From: [REDACTED]
Sent: Friday, 25 February 2022 12:30 PM
To: [REDACTED]
Cc: [REDACTED]
Subject: [External] - Response to RF12_2021/6169 621 Burwood Highway, KF - Subdivision Application
Attachments: 19095-SM01[2].pdf; 190752SPA405A.pdf; 190752SPA400A.pdf; 190752SPA401A.pdf; 190752CLP402A.pdf; 190752SPA403A.pdf; 190752SPA404A.pdf; 19095-SM01[5].pdf; DELWP Letter to KCC (Subdivision Permit) dated 10 August 2021 (PG response).pdf; Engeny responses MW Letter to KCC (Subdivision Permit) dated 9 June 2021.pdf

Please see responses below to RF12 (Greg Kent email dated 8 October 2021) from Knox City Council (KCC), incorporating requests to KCC from Melbourne Water and DELWP.

From: [REDACTED]
Sent: Friday, 8 October 2021 16:13
To: [REDACTED]
Cc: [REDACTED]
Subject: Further info review 2021/6169 621 Burwood Highway, KF - Subdivision application

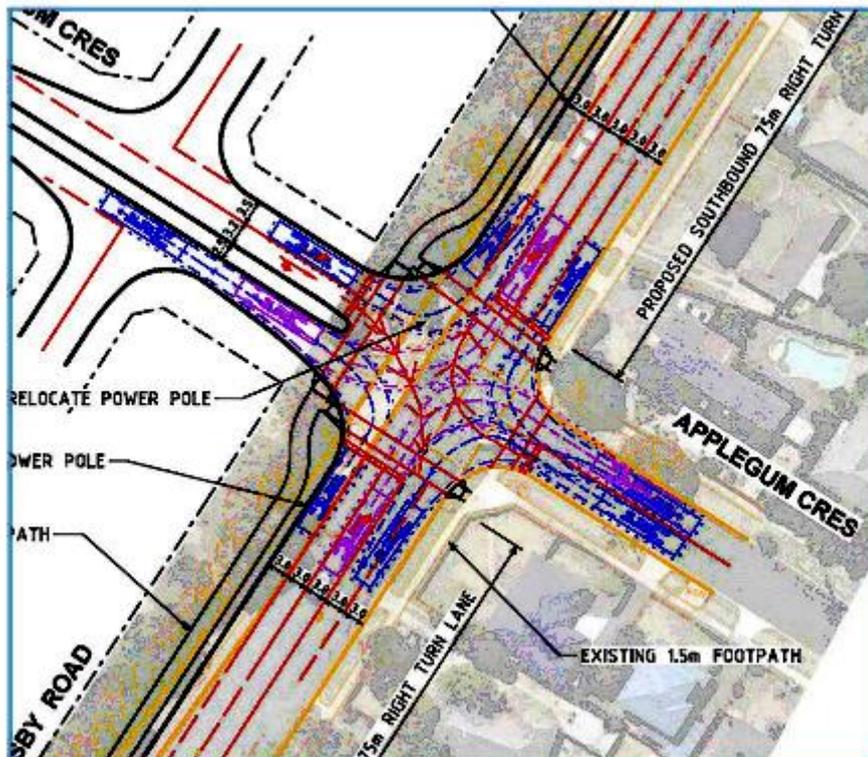
The through/right turn from the site at the intersection of Scoresby Rd and Applegum Cres is 3 times as high as the through/right at the intersection of Burwood Hwy and Lakewood Res. Is a dedicated right arrow needed for access out of the estate?

These movements are not comparable, as the Lakewood Drive intersection only serves a small DELWP office. The intersection analysis shows that the shared right and through movement from the site operates with a Degree of Saturation of under 0.6, which indicates it is only operating at about 60 per cent of its capacity. The operation as shown therefore, is very good.

Note that there is only expected to be a limited through volume from west to east, so the shared lane has a minimal impact. Due to the constraints of Applegum Crescent opposite, the right turn lane must be shared with the through

lane, otherwise the through movement will not align with the departure side of the intersection. A separate right turn arrow may therefore be blocked by an occasional through movement and providing a separate right turn phase will take away time from the intersection time and impact on other movements. Given that this movement operates at approximately 60 per cent of capacity, no modifications to this operation are required.

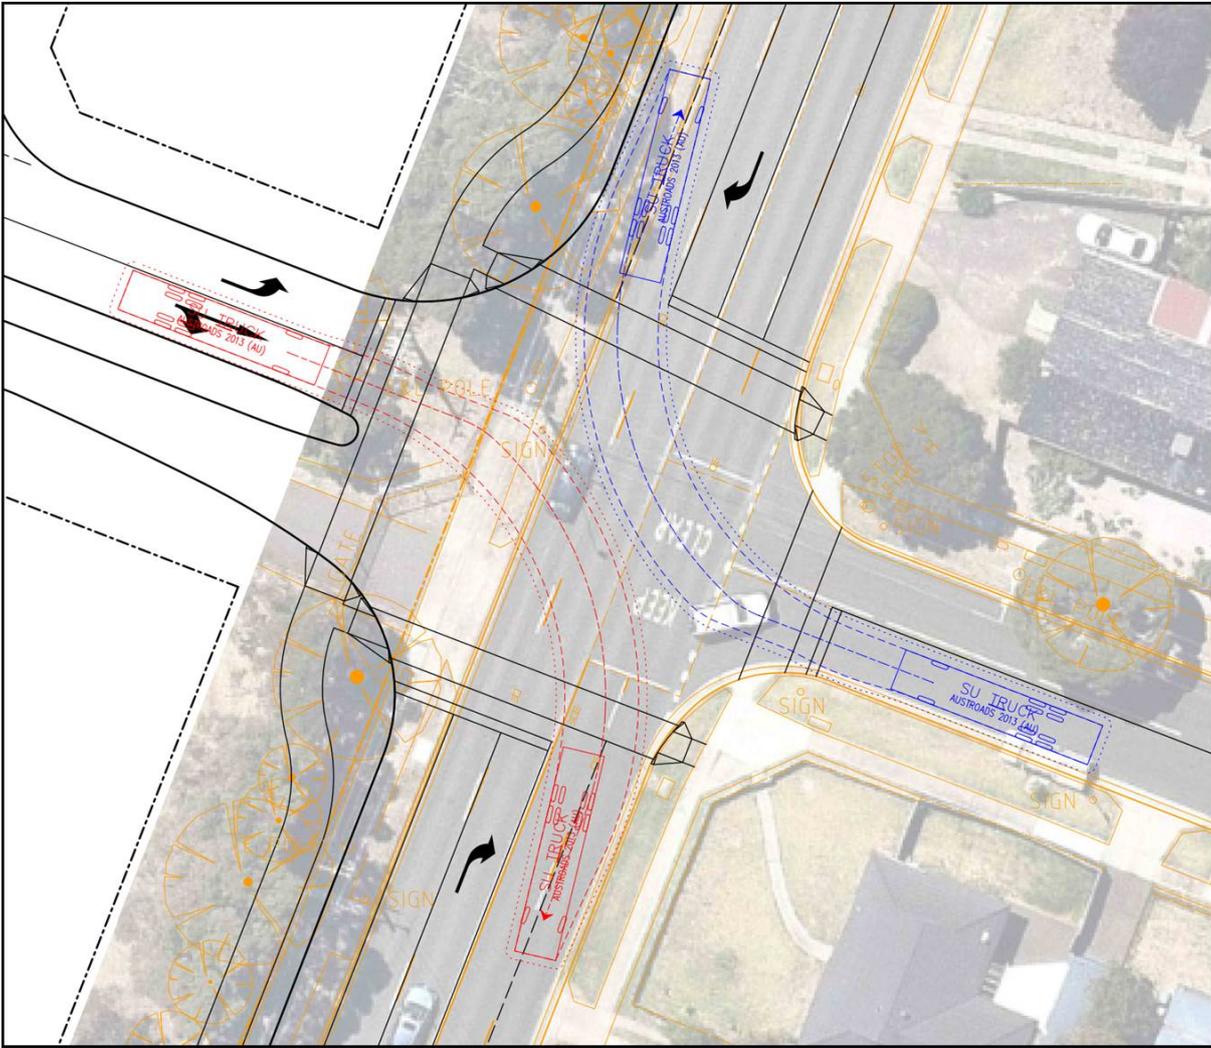
DoT will be the responsible Road Authority to review and approve the intersection capacity and lane configuration. As such, similar to the need for a left turn slip lane from the development onto Scoresby Road, Council will rely on the preference from DoT for the intersection layout. With the intersection design, the developer needs to ensure opposing right turn movements from Applegum Cres have enough vehicle clearances at the same phase.

Swept path diagrams by OMG have been prepared for the opposing right turn movements as shown below, confirming that these can occur simultaneously, even for large 12.5m trucks/buses (SU TRUCK as shown).

Drawing Title 621 BURWOOD HIGHWAY, KNOXFIELD STREET 3 / LANEWAY D CONFIGURATION SWEEP PATH ANALYSIS - EXIT		
Designed DK	Drawing Number SPA404	Revision 73 D1 A
Scale 1:250 @ A3	Project Number 190752	Drawing Number SPA404

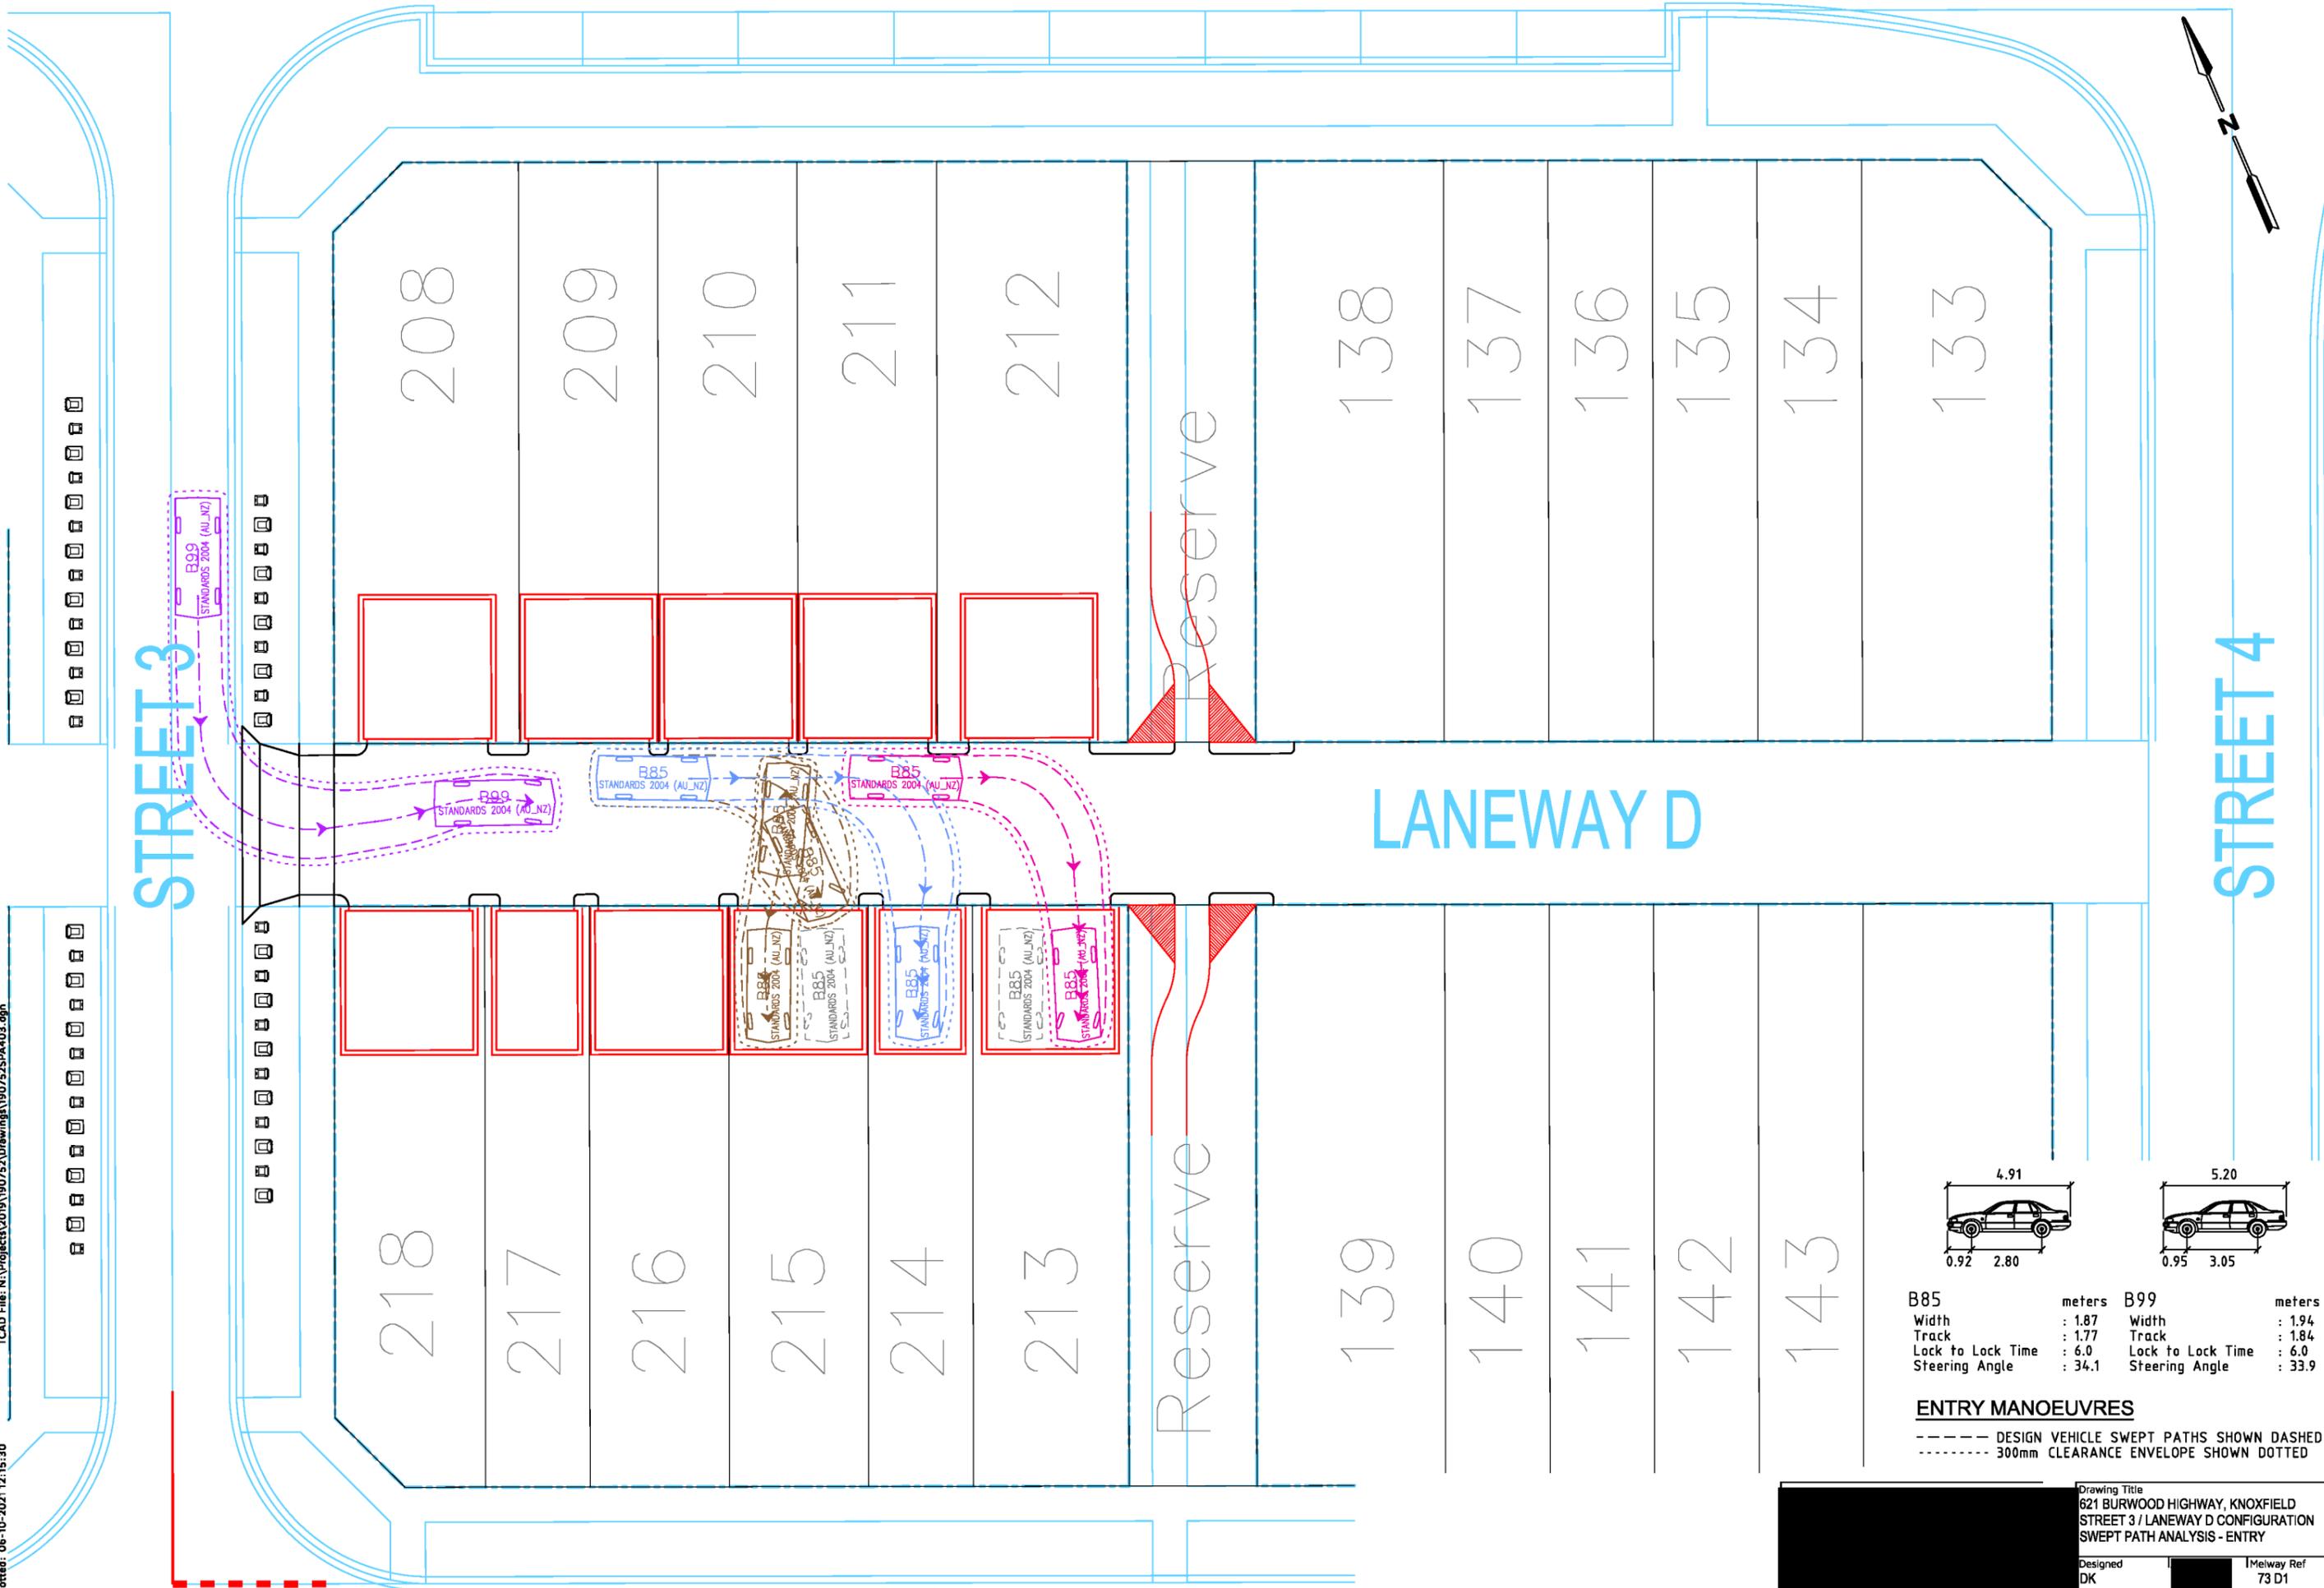
Council requires examples of swept path diagrams for single, double garages access for the laneway. The diagrams should also display the location of planter boxes. It helps to investigate their placement. At this stage, it is understood that no waste bins are proposed along the laneway.

An example laneway design has been prepared (refer attachment 190752CLP402A) as noted earlier. Swept paths (refer attachments 190752SPA403A and 190752SPA404A) have also been prepared by OMG. Example double or single garages have been shown based on the lot width, with planting outstands shown between garage doors, extending 0.5m into the 7.0m laneway. The attached swept paths demonstrate suitable garage access, with no overhang of the landscape outstands (clearance envelope only). Whilst some spaces may require a corrective movement, the single garages, and at least one space in each double garage are shown to be accessible in the minimum number of movements.

TEMPORARY STORMWATER MANAGEMENT PLAN
1:1250 @ A1

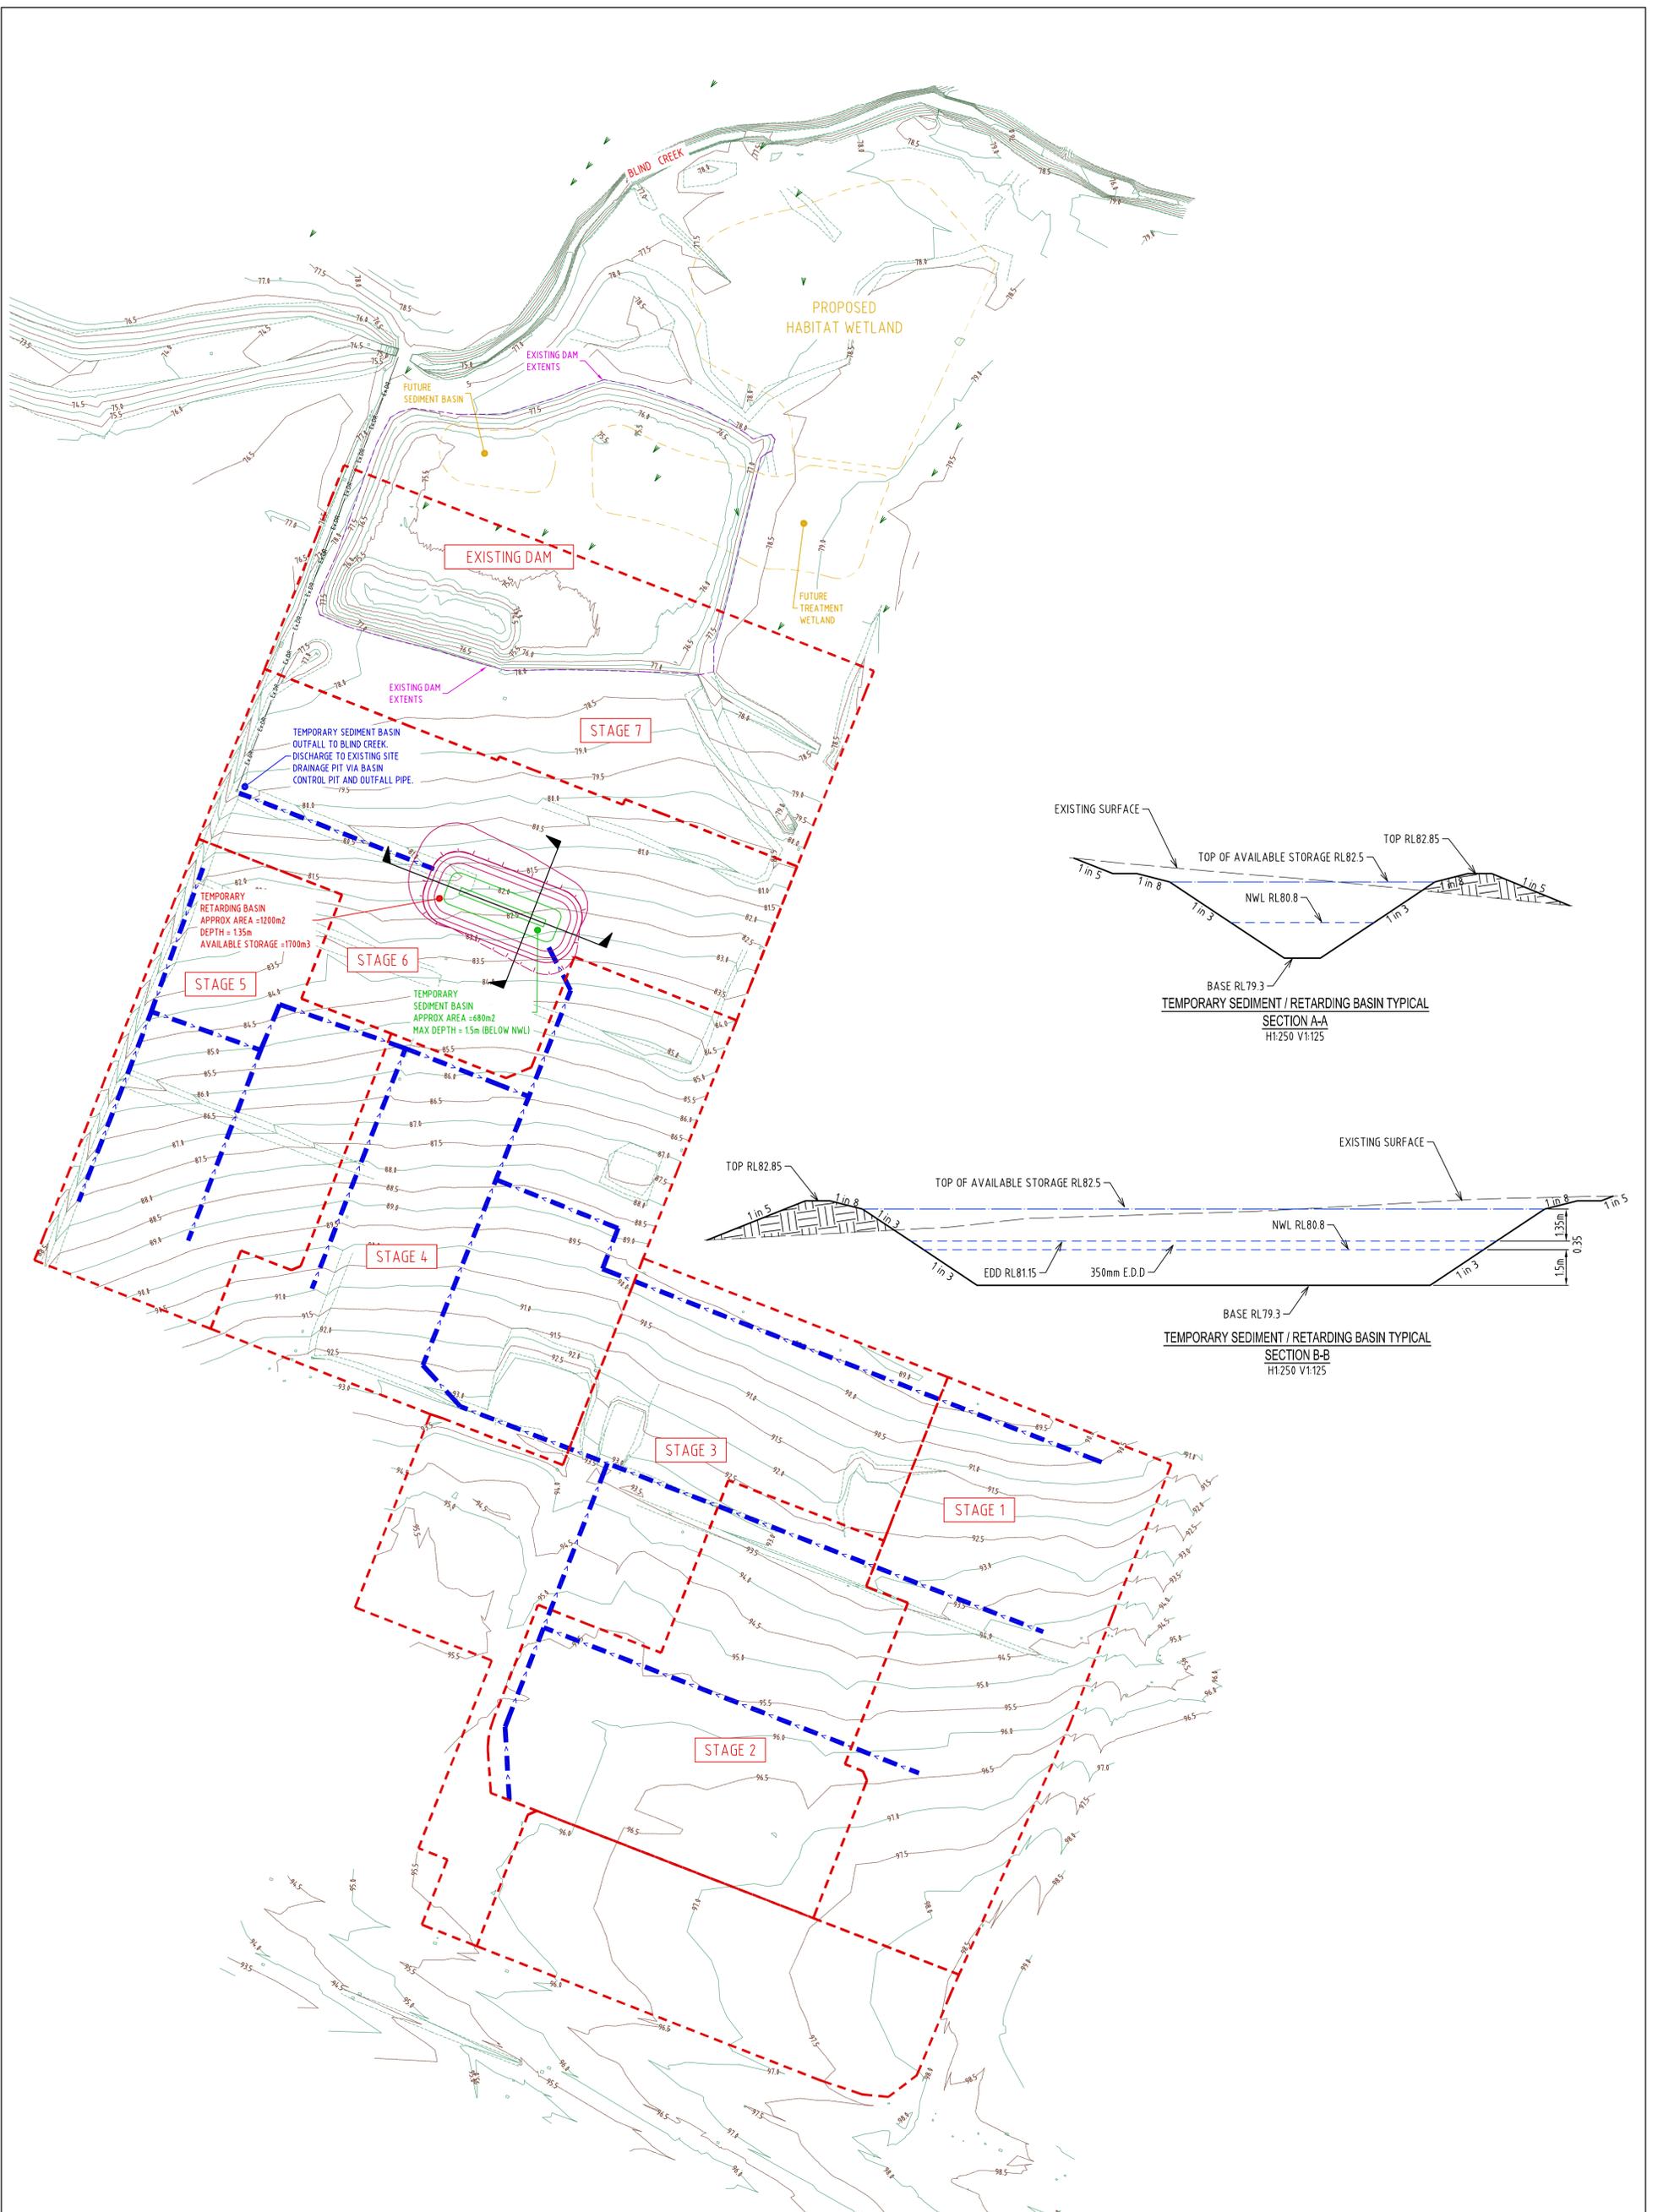
Response – The information provided is considered unsatisfactory. Noting that the existing dam is located within the balance lot and works from Stages 1 and 2 will be reliant on works through the balance lot to the wetlands. The following application requires at Schedule 2 to Clause 37.02 Comprehensive Development Zone are as follows:

- **proposed earthworks and levels for future development.**

This extends also to proposed drainage/stormwater management works.

Refer to the revised PGA temporary stormwater management plan (attachment 19095-SM01 [Rev. 5]) which shows additional detail for the temporary sediment pond (section, levels and earthwork cut / fill batters). This includes the proposed drainage outfall alignment, which it is important to note does not connect to the existing dam or require construction works in the vicinity of the existing dam.
